Robert J. Meyers
U.S. Environmental Protection Agency
November 7, 2011

EMC is pleased to respond to Draft 2 of Version 1 of the ENERGY STAR® Program for Data Center Storage Specification with our comments and recommendations. We commend you on the progress that has been made in producing this draft, and hope that our observations and proposed options help further the ENERGY STAR Program. While the attached document addresses a number of specific areas of the specification, we'd like to highlight two general themes to our comments:

DISK SCALING PROPOSAL TO REPLACE BOOKENDS

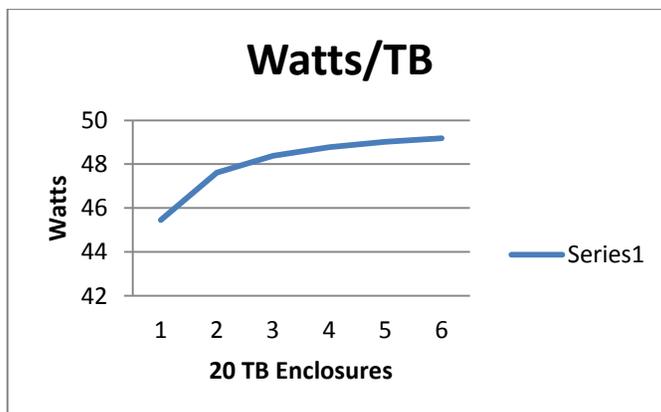
1. In modular architectures that have separate power supplies for controllers versus disk enclosures (also called shelves and/or drawers), the burden of the controller power draw will be amortized over the drive shelves. This is also true of Online 3 products where some drives are enclosed with the controllers, and capacity expansion occurs with additional shelves.

2. This amortization can be seen to drive to an asymptotically small burden in relatively few drawers for Online 3 and Online 4 systems (in as few as 2-3 disk enclosures for any given drive type).

3. Each disk shelf/drawer contains some overhead logic along with power and infrastructure to support the drives that will be installed. This overhead is additive to the power draw of each drive that is added to the enclosure. Each enclosure draws its maximum power (both at idle and under active I/O load) when all slots are filled. The power draw grows linearly in addition to the fixed overhead.

1. If each disk shelf/drawer can hold 20 drives, each fully loaded enclosure draws Y watts, where $Y = EO + 20 * DP$ (Enclosure draw = Enclosure Overhead (EO) + Disk Power (DP)*20). If the Controller Overhead (X) = $Y/10$, the controller burden on the first drawer is .1Y (10%); across 3 enclosures, or 3.1Y, the burden drops to <3%.

Replace bookends by a methodology that recognizes the near-linear scaling of incremental disk enclosures/drawers in modular scale-out storage architectures. Under this method, manufacturers would provide 2 test data points for each type of target storage media. The first test point would be the product's controller(s) as intended to be configured for the idle test datapoint along with a single full enclosure. The second test point would be the same controller configuration with sufficient full drawers to drive the controller burden to <5% per drawer. A method of supporting mixed drive types in a single drawer, or multiple shelves of different drive types would make this form of testing even more productive for both customers and manufacturers.
